Legal issue:

Question:

**Should the driver’s door be considered as an emergency  
door or emergency exit?**

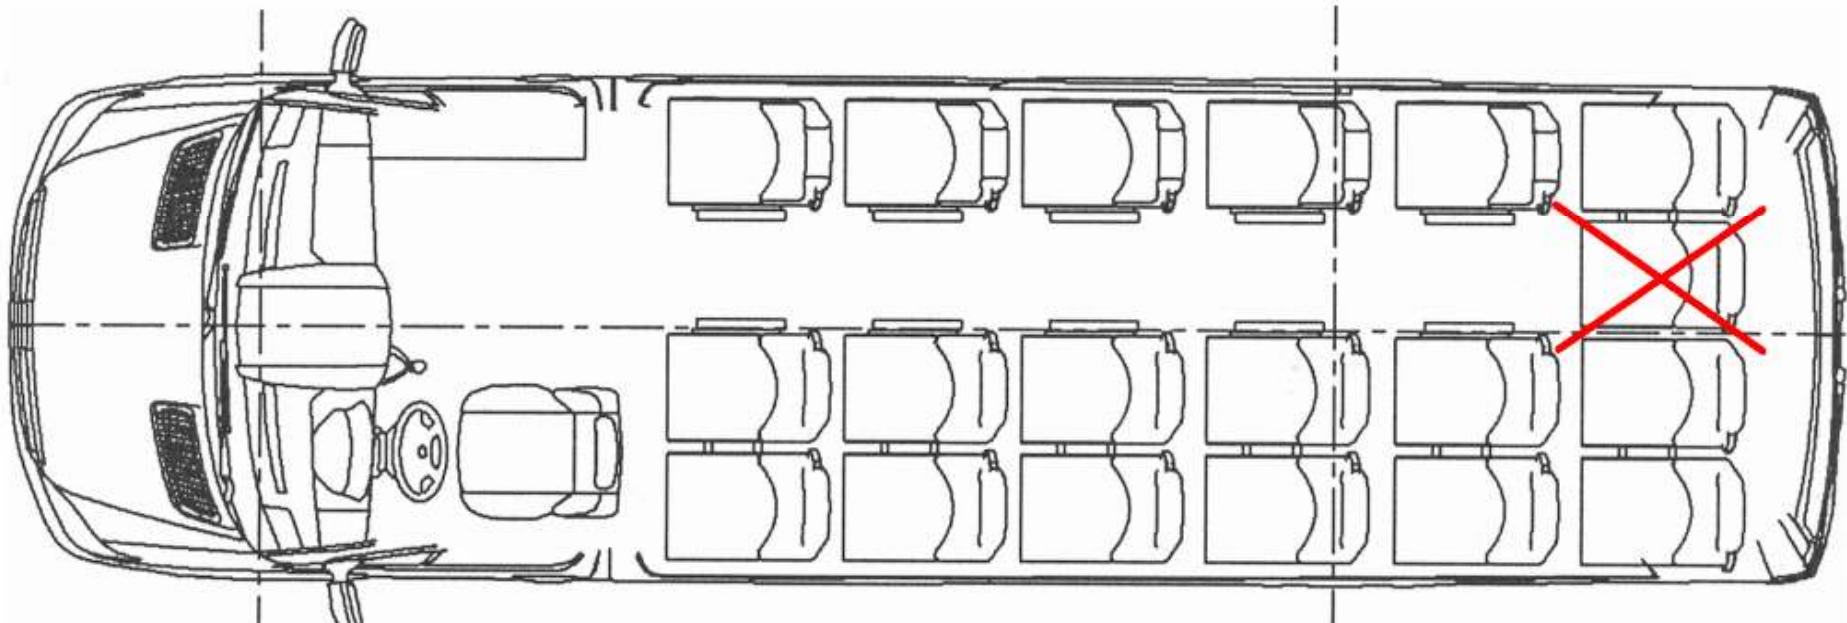
**The emergency DOOR should provide an unobstructed way of evacuation. In case of a roll-over or tip-over accident (as presented), a vehicle in question does not provide such life-saving provision. The service door is blocked, the driver's door is very hard to open from the inside and the driver, if dead or injured, is an obstacle that is quite impossible to pass.**

**This requirement is also not met by the vehicle in question.**

**The driver's door should ONLY be considered as an emergency EXIT.**

**The vehicle configuration in question should NOT obtain a type-approval certificate.** That should only be possible if there is a free access to the rear door that would then be the emergency door, i.e. by removal of one seat from the rear row.
